Project Name: Munjoy Heights

Project Description: New Construction of 29 Residential Townhomes.

Comments Submitted by: Marge Schmuckal/Zoning on 12/6/2013

Comments Submitted by: Marge Schmuckal/Zoning on 11/27/2013

AVERAGE GRADES DIAGRAMS

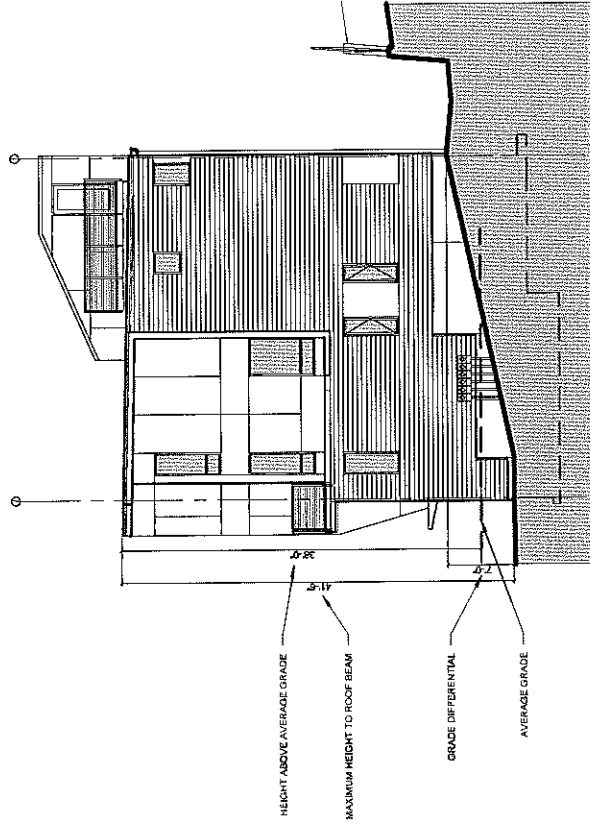
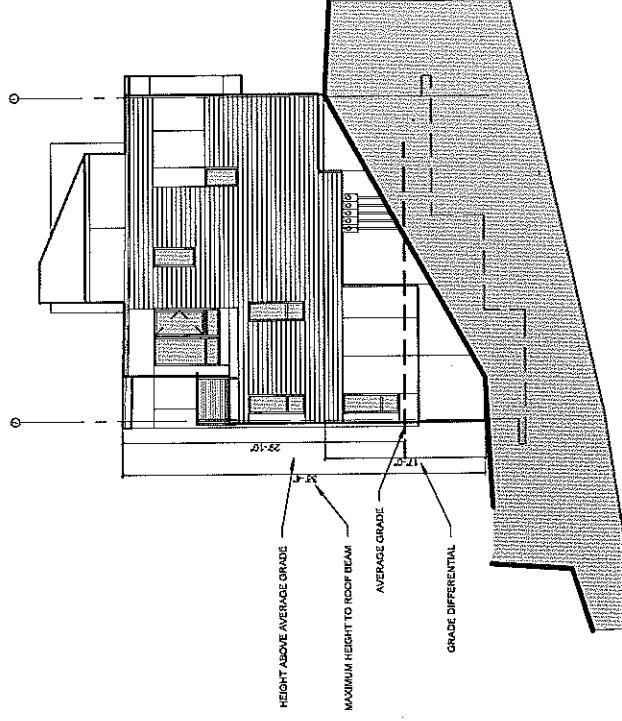
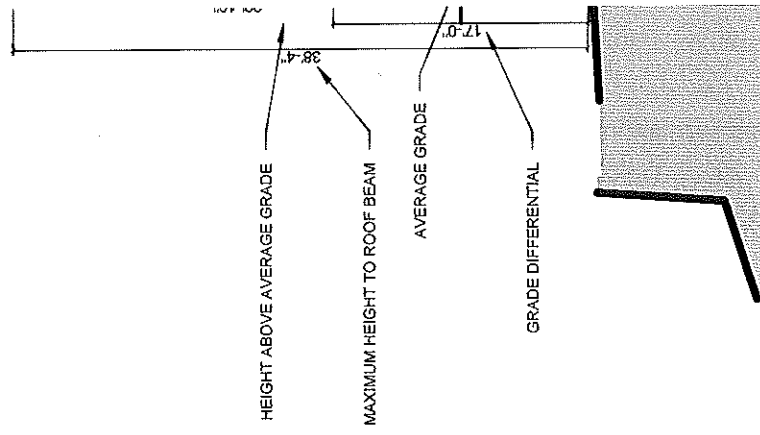
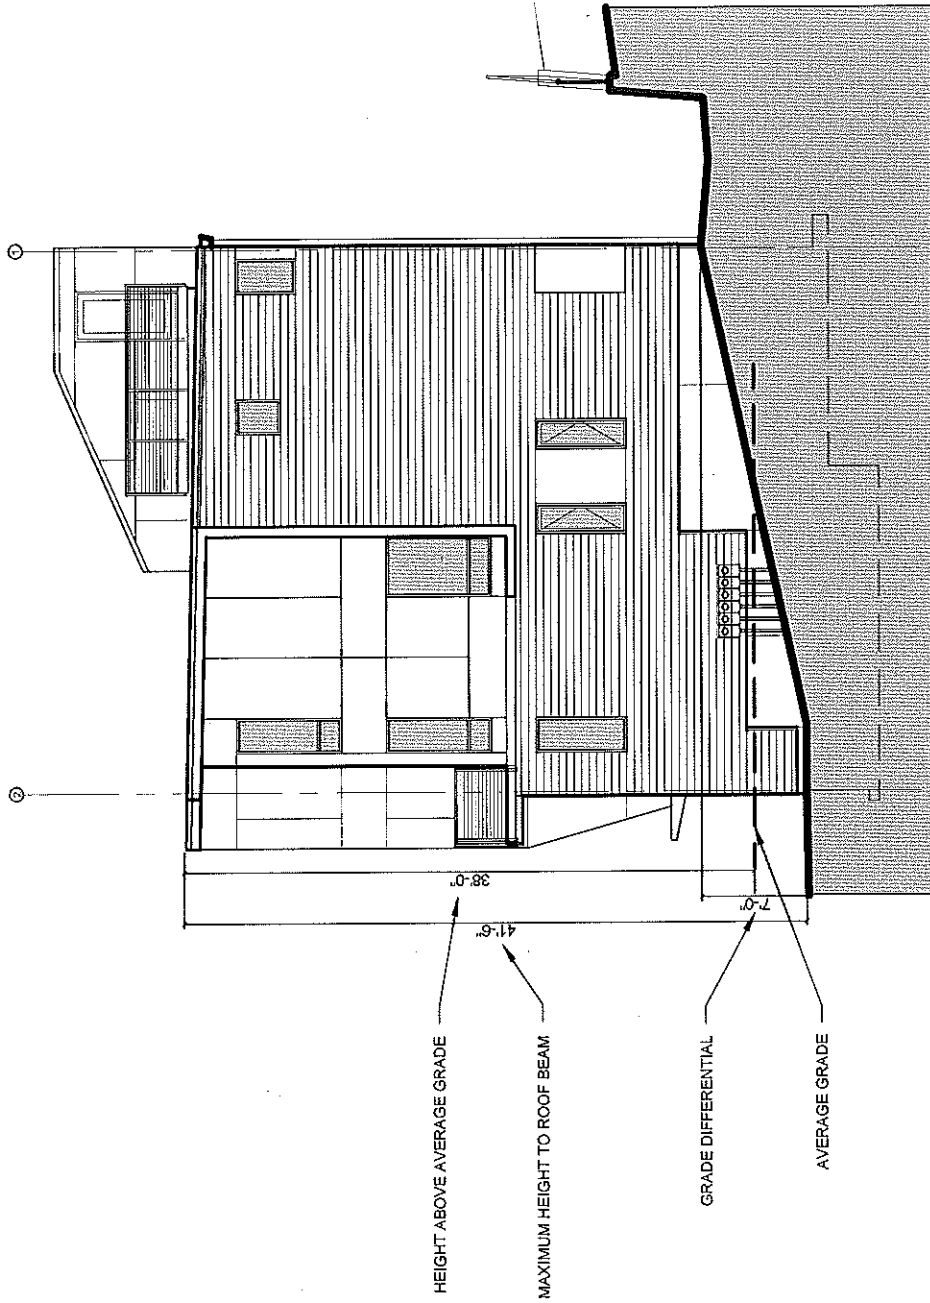
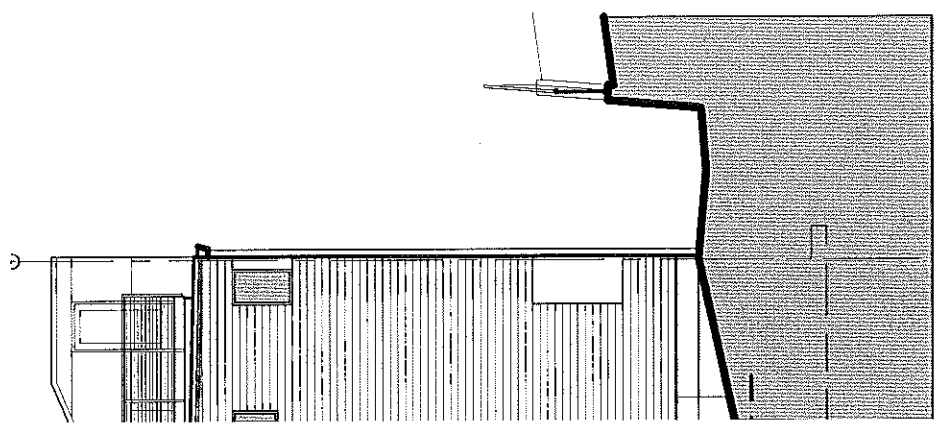
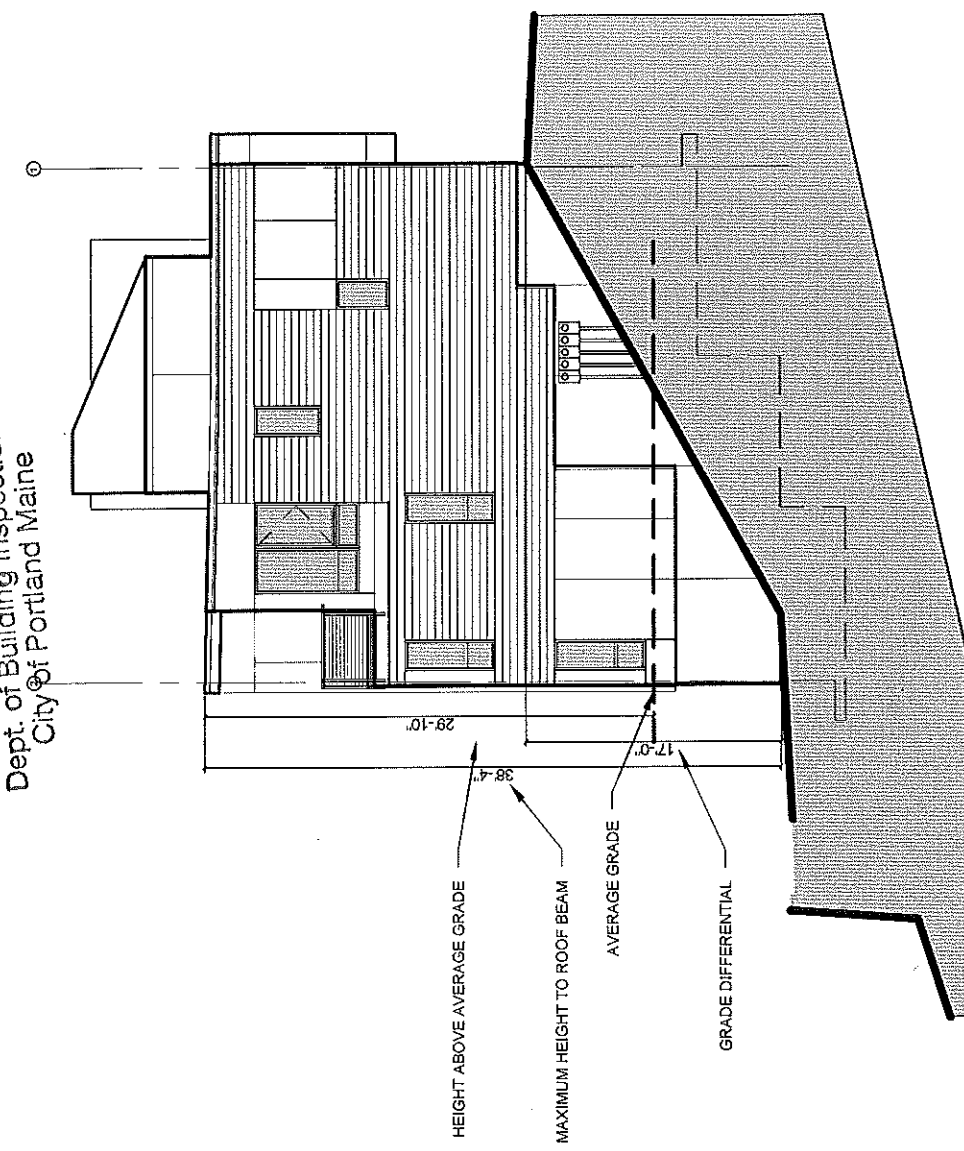
Marge's original review comment on 10/18/13 stated that the height requirement appeared to be met, but that the narrative had mentioned average grades, She wanted to see the methodology for the average grade. Based on the email from Ryan Senatore and the Average Grades Diagram dated 12.04.13, the methodology has been shown and the heights for the three story and four story buildings from the average grade is below the 45' maximum hieght requirement.

The height requirement appears to be met. However, the narrative mentioned average grades. I did not see the methodology for the average grades. The average grade was not indicated on the building elevations. Please explain the details a little bit more.

Please see the explanations below and the associated diagrams as to how we calculated the average grades for Munjoy Heights, note that the grades across the lengths of the buildings are consistent so the average grade is a simple average of the grades along the sloped sides of the buildings.

- 1.) The maximum height to roof beam for the 4 story structure as indicated on the drawing is 41'-6" We determined the average grade at the 4 story buildings by determining the grade change on the sloped side grades of the building which is 7' so we divide that by 2 to get 3.5' and subtract that from our maximum height of 41'-6" to get a Maximum height to top of roof beam above average grade of 38'-0" which is less than the 45' Maximum allowed by Zoning.

- 2.) The maximum height to roof beam for the 3 story structure as indicated on the drawing is 38'-4" We determined the average grade at the 3 story buildings by determining the grade change on the sloped side grades of the building which is 17' so we divide that by 2 to get 8.5' and subtract that from our maximum height of 38'-4" to get a Maximum height to top of roof beam above average grade of 29'-10" which is less than the 45' Maximum allowed by Zoning.

SK-2

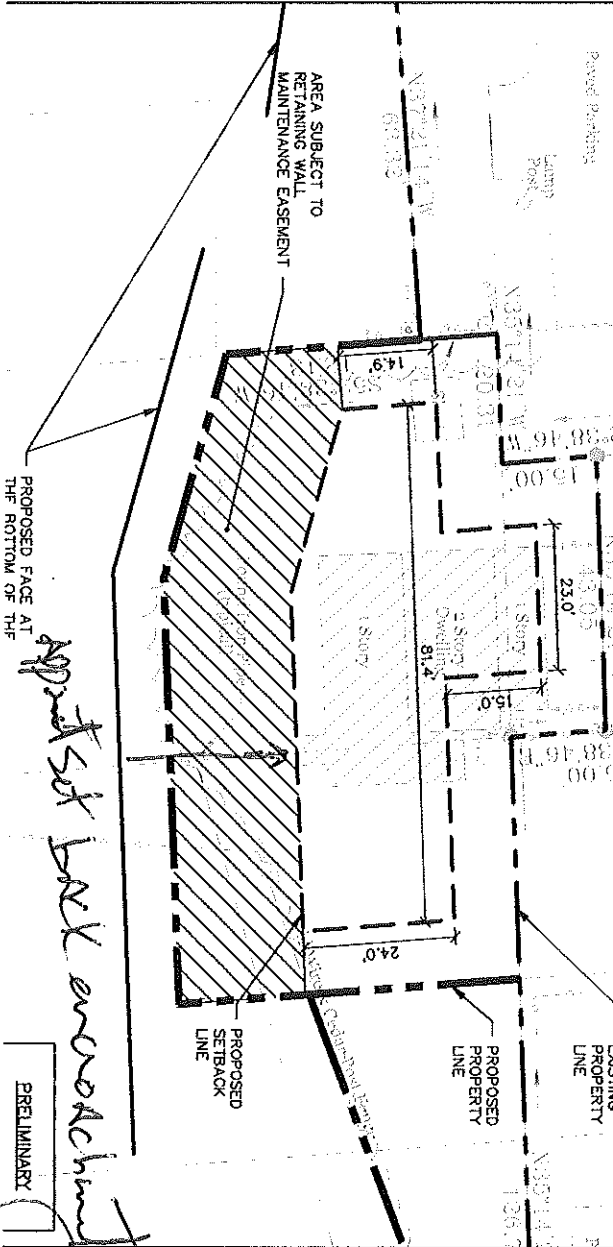
I reviewed the submitted response letter dated 11/19/2013. None of my zoning concerns were addressed in that letter. I would like to see them addressed. I did view plan SK-2 which concentrated on the 2-story building that is to remain. The zoning analysis looks fine, but I still see an apparent setback encroachment that is being created by this lot division. This encroachment should be corrected.

Appoint set back encroachment

The second attached email was forwarded on to Marge on 10-21-13. I believe the encroachment discussed below is related to the existing bulkhead.

My interpretation of the rear building setback zoning requirements precludes rear building setbacks for "attached accessory structures with ground coverage less than 100 square feet". The proposed utility closet and bulkhead have a ground coverage of less than 100 s.f.
